RESULTS OF CIRCULATION

Subject: RE: C03W05.016 1061 and 1071 Queen St W - Place of Worship

C03W05.015 - Place of Worship (OPA ZBA)

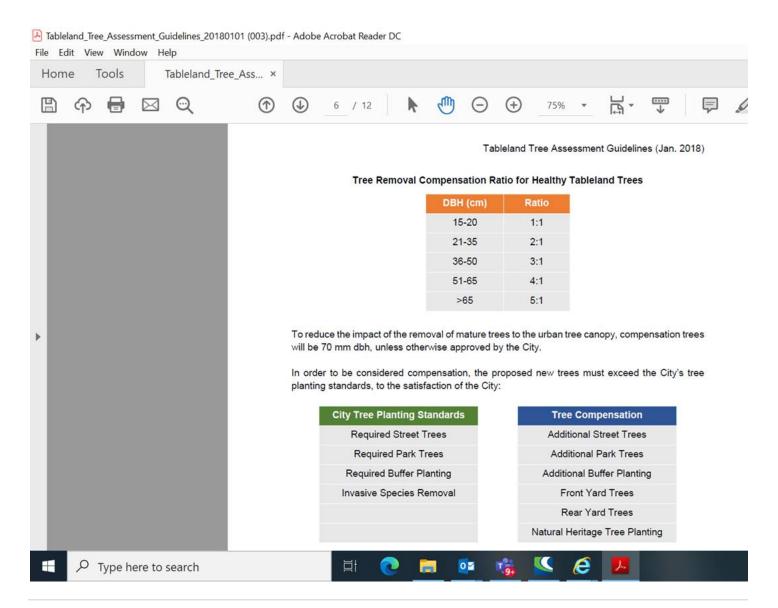
I just need the TER report to clarify the following:

If there are healthy tableland trees being removed that fall within the compensation ratio's (see below chart), the report just needs to state how may compensation trees or cash-in-lieu required at the site plan stage.
